TOMBALL INDEPENDENT SCHOOL DISTRICT

RFP/CSP #1002-26 Issued: June 5th, 2026
REQUEST FOR COMPETITIVE SEALED PROPOSALS
FOR THE CONSTRUCTION OF A NEW
HVAC Control System at the Tomball High School

Addendum No. 03

July 22nd, 2026

SHEET NUMBER: M2.21

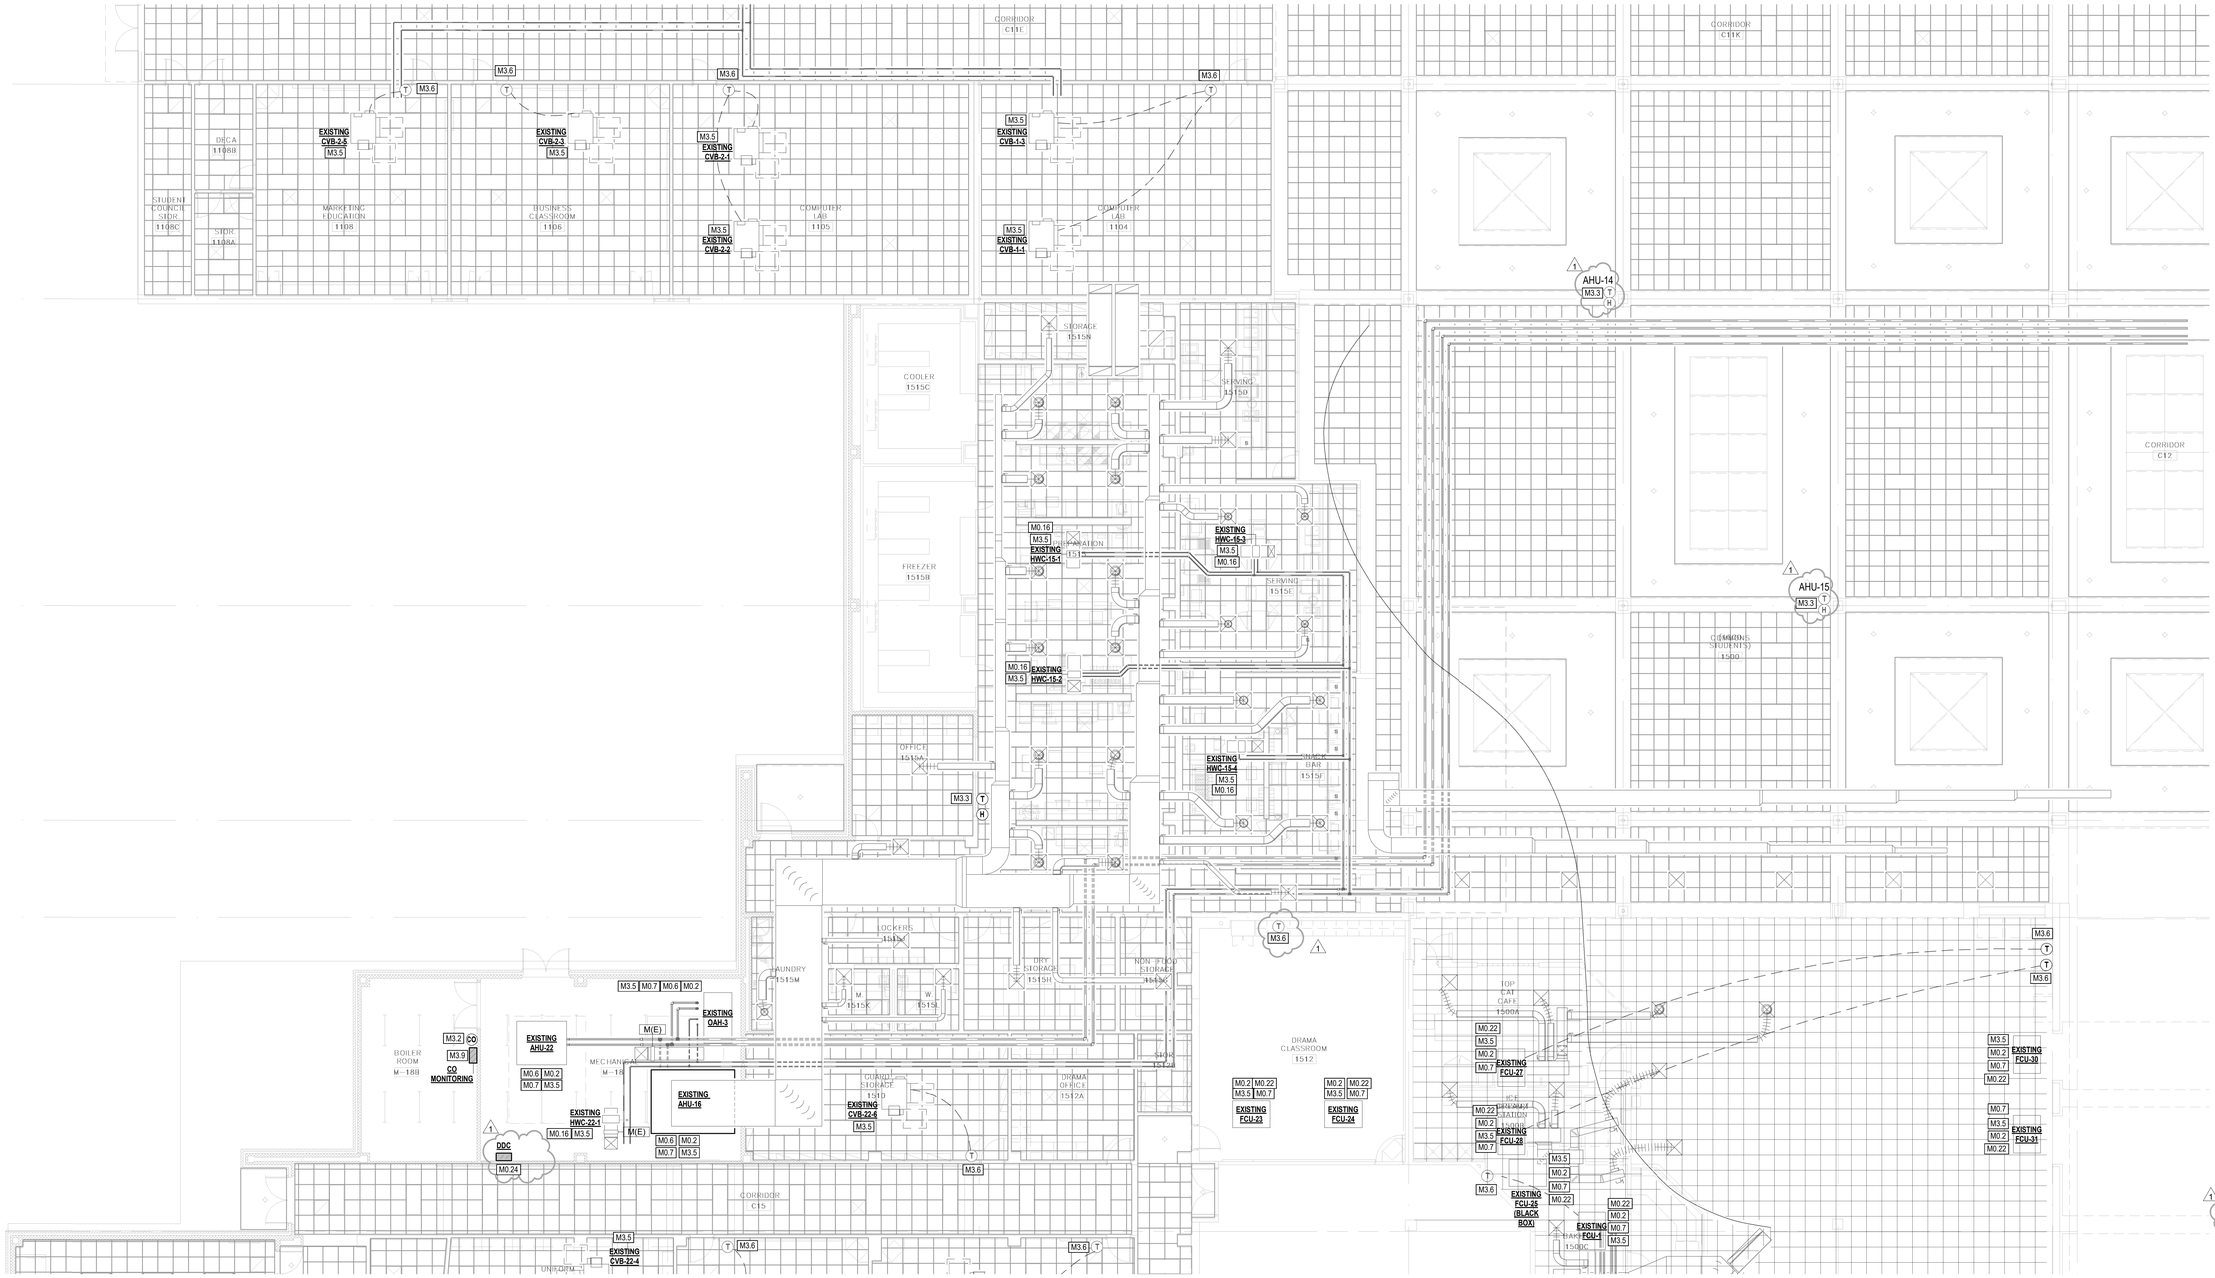
Item 08 Sheet M2.21 – MECHANICAL PLAN LEVEL 1 – OVERALL

1 MECHANICAL PLAN LEVEL 1 - AREA G

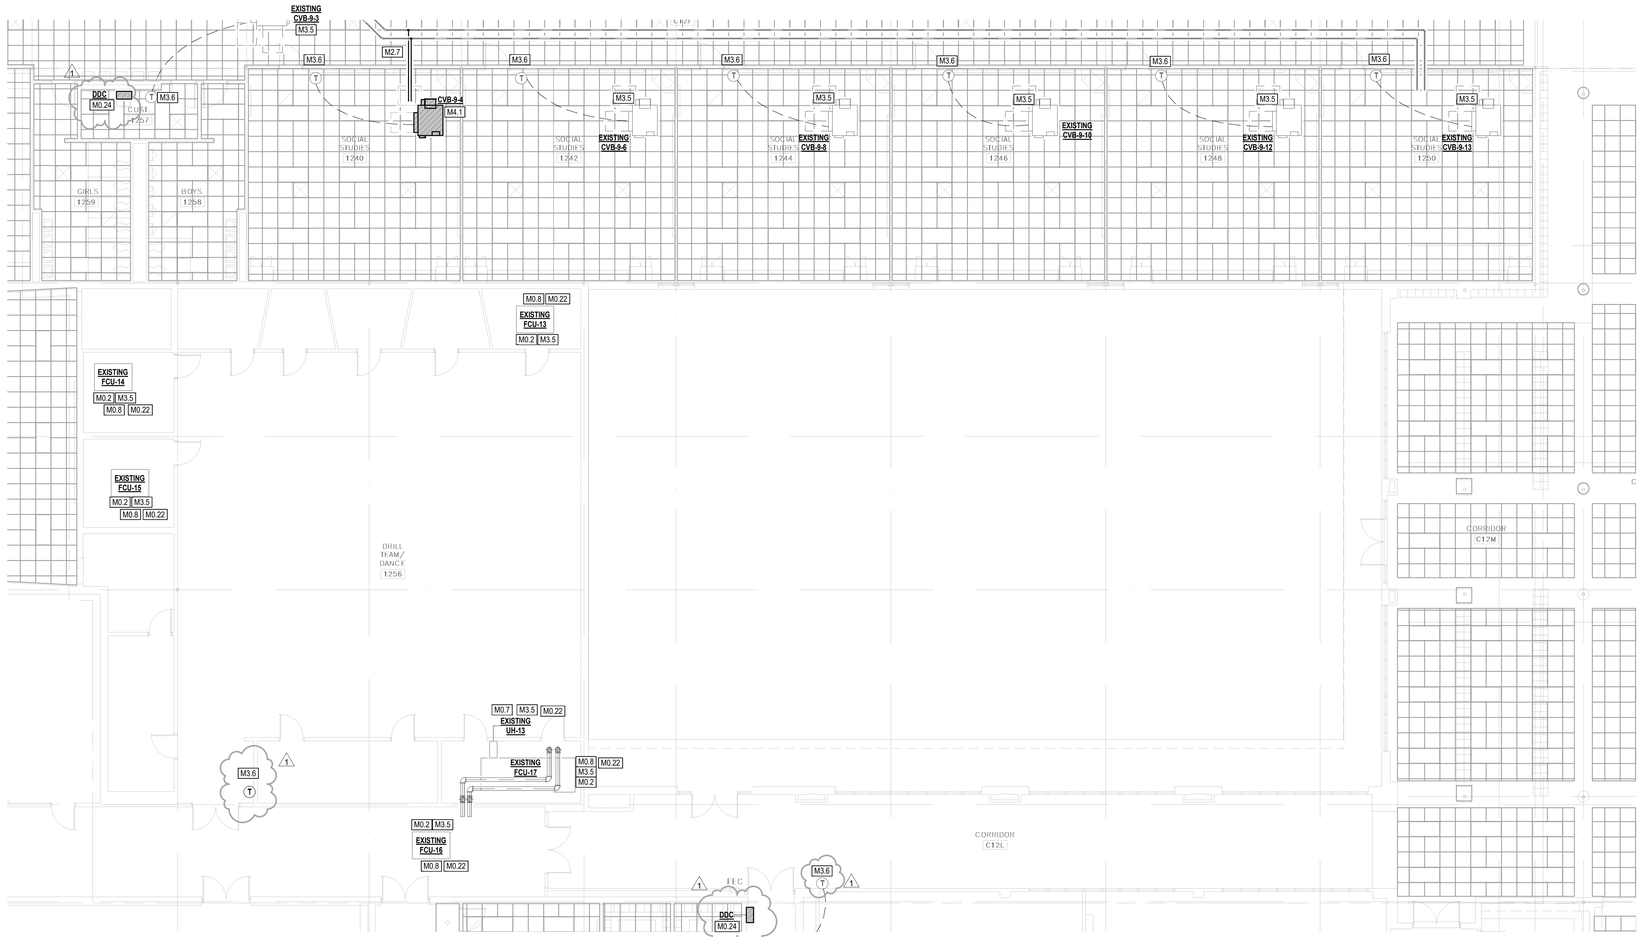
Item 05 **Sheet M2.21G – MECHANICAL PLAN LEVEL 1 – AREA G**

Item 35 Sheet M2.21G – MECHANICAL PLAN LEVEL 1 – AREA G

C. Added keyed note M0.24 "EXISTING DIGITAL CONTROL PANEL SHALL BE REPLACED. PROVIDE NEW CONTROL PANELS COMPLETE WITH ALL REQUIRED CONTROLLERS, POWER SUPPLIES, COMMUNICATION MODULES, RELAYS, TERMINAL BLOCKS, TRANSFORMERS, AND ANCILLARY COMPONENTS NECESSARY FOR A COMPLETE AND FULLY OPERATIONAL CONTROL SYSTEM. SIZE AND CONFIGURE THE NEW CONTROL PANELS TO ACCOMMODATE ALL EXISTING AND NEW CONTROL POINTS AS REQUIRED TO IMPLEMENT THE SEQUENCE OF OPERATION SPECIFIED FOR THE EQUIPMENT SERVED." to control panels.

SHEET NUMBER: M2.21M

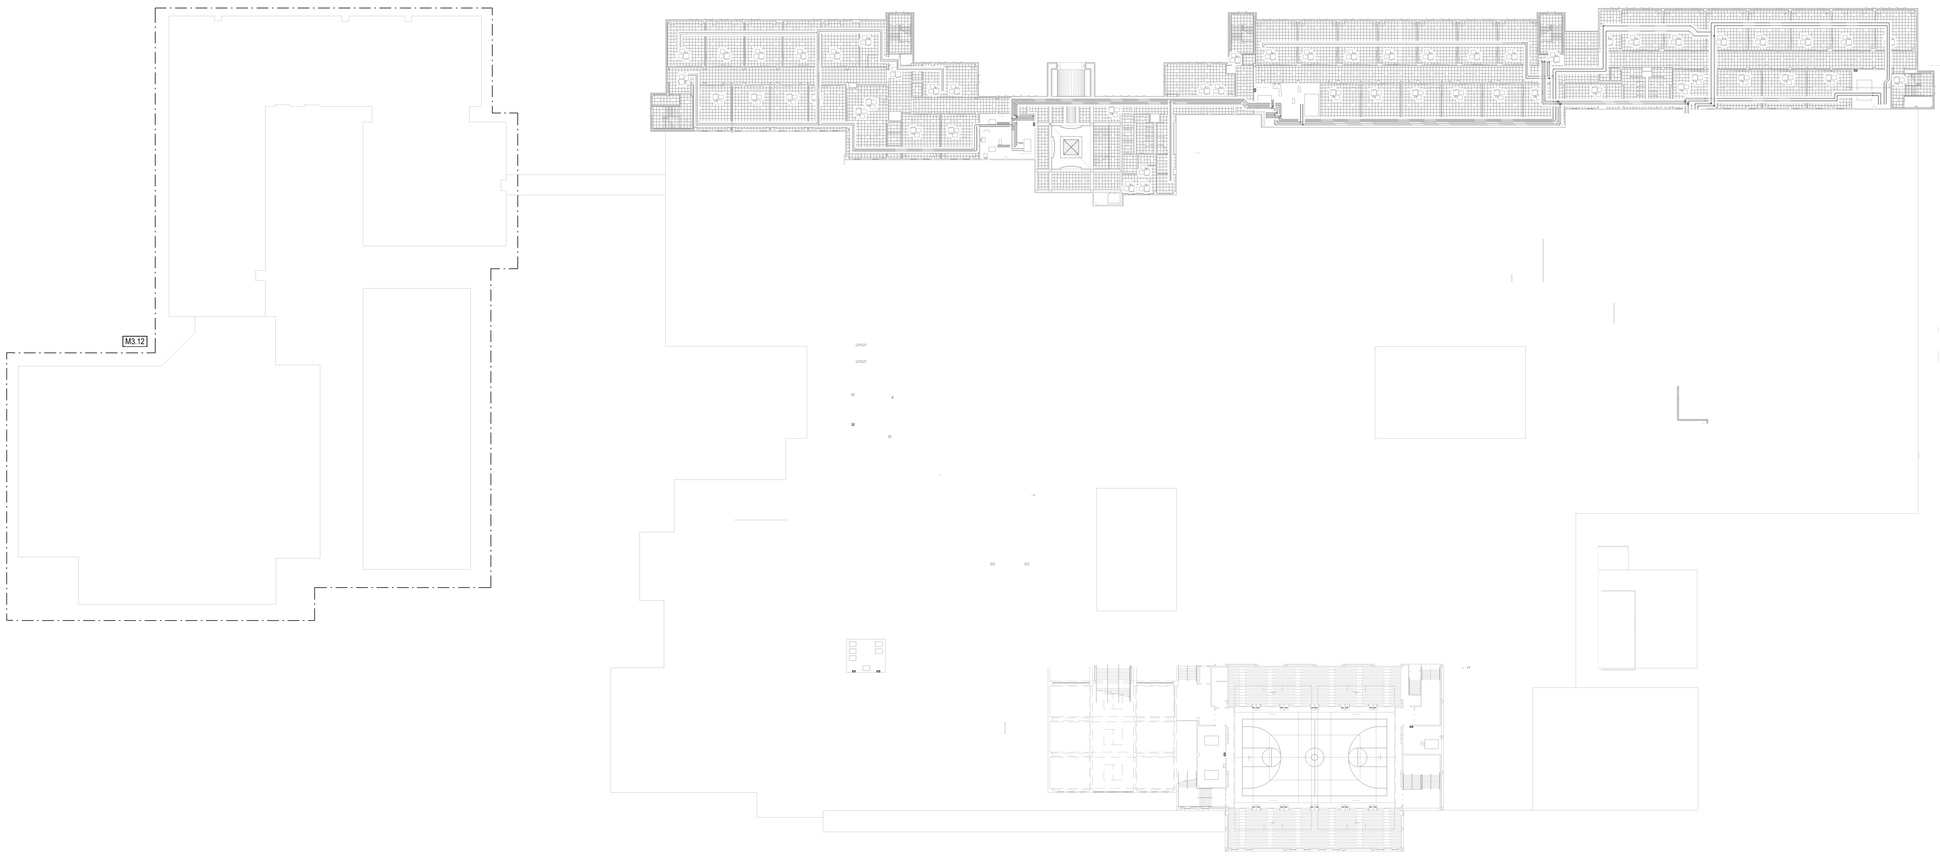
Item 10 **Sheet M2.21M – MECHANICAL PLAN LEVEL 1 – AREA M**

B. Added DDC to MECH M-15 and MECH M-16.
C. Added keyed note M0.24 to control panels.
D. Clarified location of EXISTING FCU-15,16, and 17.
E. Revised keyed note M0.16. Applicable to HWCs in M-15 MECHANICAL and any other multi zone hot water coils not listed but located in this area.

SHEET NUMBER: M2.22

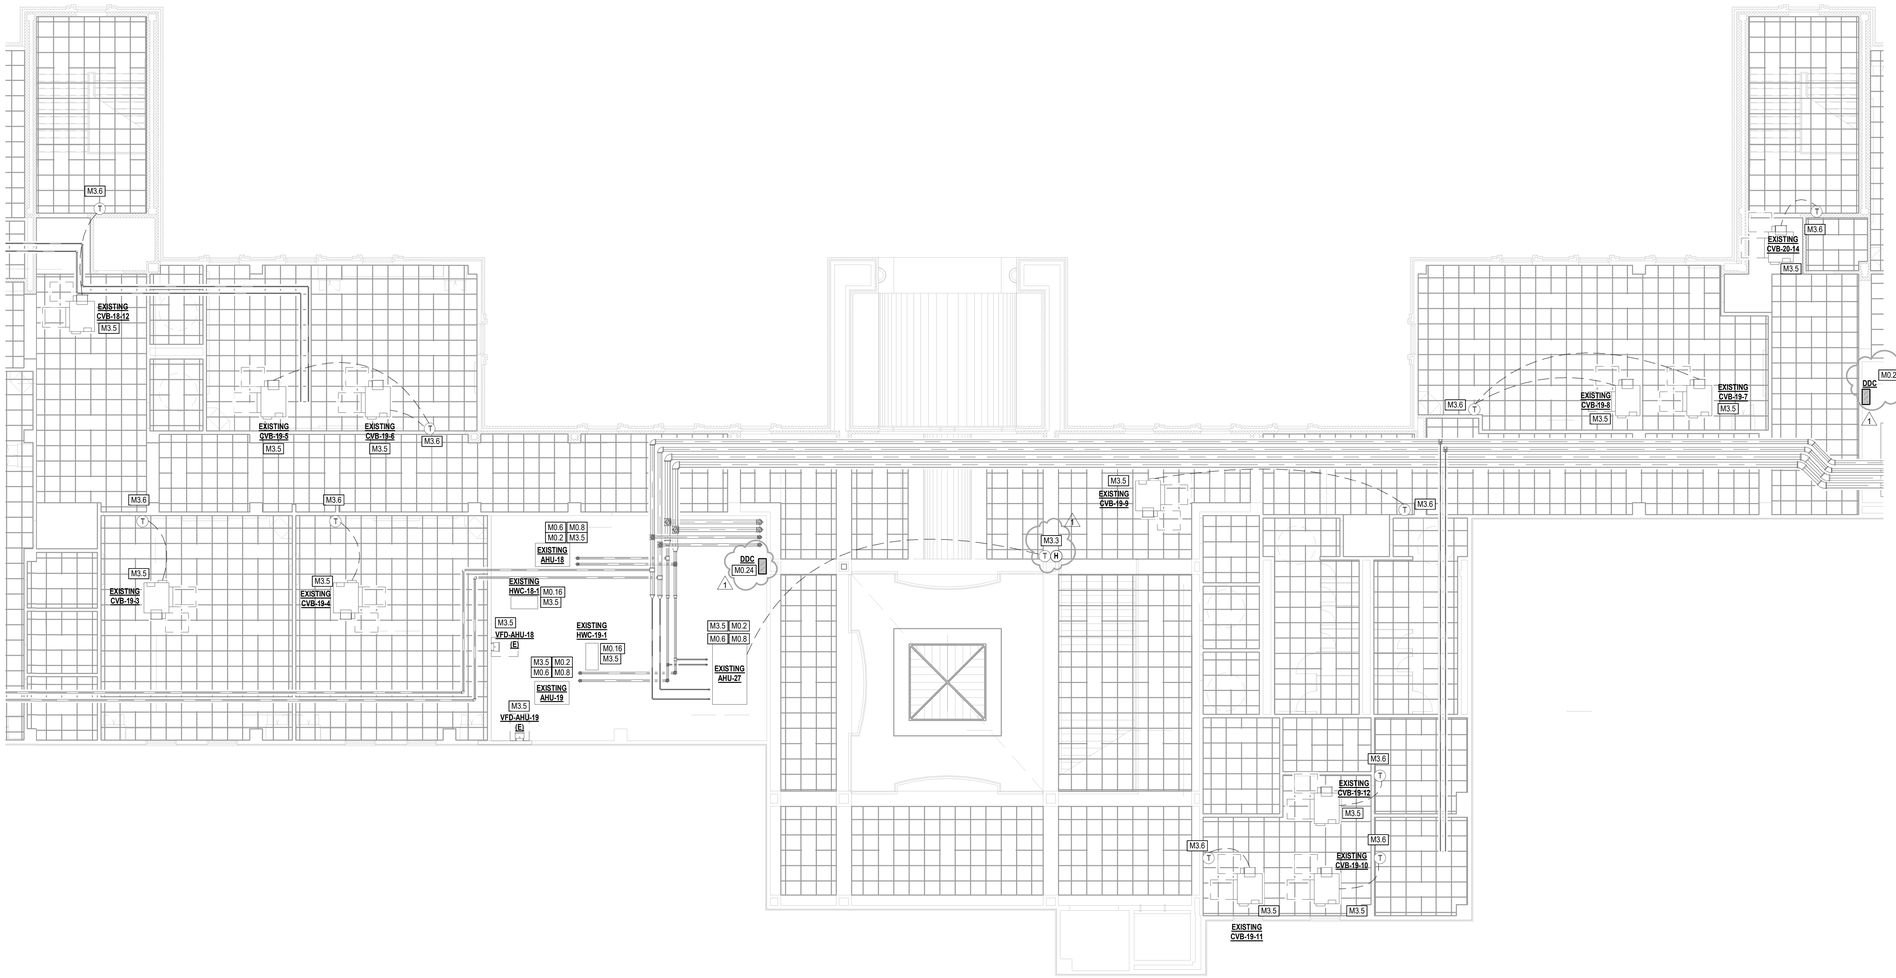
Item 09 Sheet M2.22 – MECHANICAL PLAN LEVEL 2 – OVERALL

1 MECHANICAL PLAN LEVEL 1 - KITCHEN
1/8" = 1'-0"

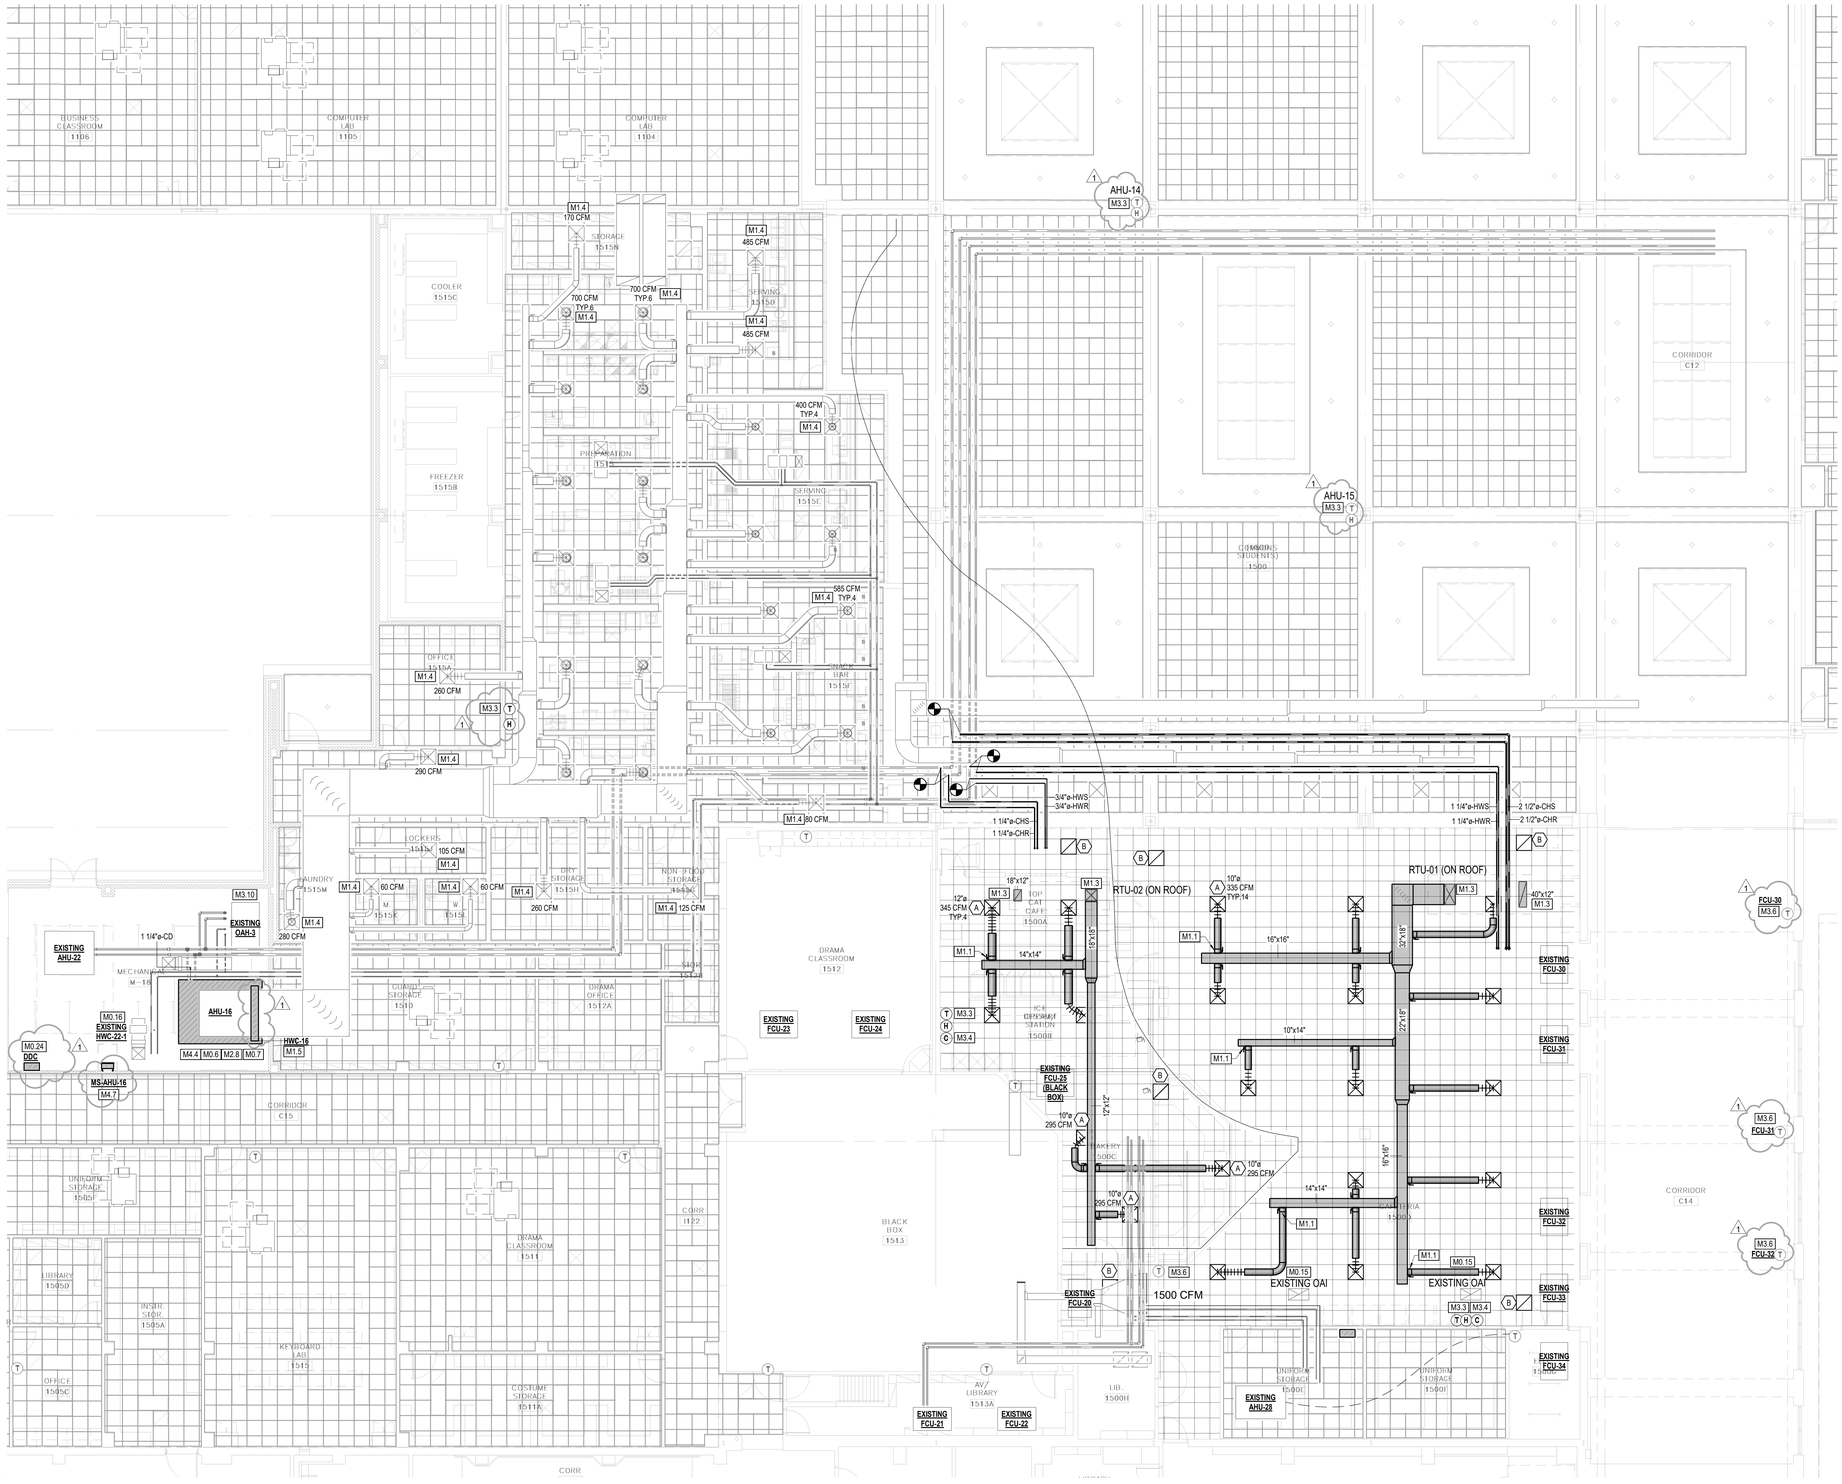
Item 13 Sheet M3.02 –MECHANICAL PLAN LEVEL 1 – KITCHEN/CAFETERIA ALT 1

A. Revised size of new HWC-16.
B. Clarified location of existing thermostat to be replaced with combination temperature/humidity sensor for AHU-14.
C. Clarified location of existing thermostat to be replaced with combination temperature/humidity sensor for AHU-15.
D. Clarified location of FCU-30, 31, 32, 33, and 34 existing thermostats to be replaced.
E. Changed keyed note M4.7.
F. Changed 'VFD-AHU-16' to 'MS-AHU-16'
G. Added DDC to M-18 MECHANICAL.
H. Added keyed note M0.24 to control panel.
I. Revised keyed note M0.16. Applicable to HWC-15-4, HWC-15-2, HWC-15-3, HWC-15-1 1 and any other multi-zone hot water coils not listed but located in area.
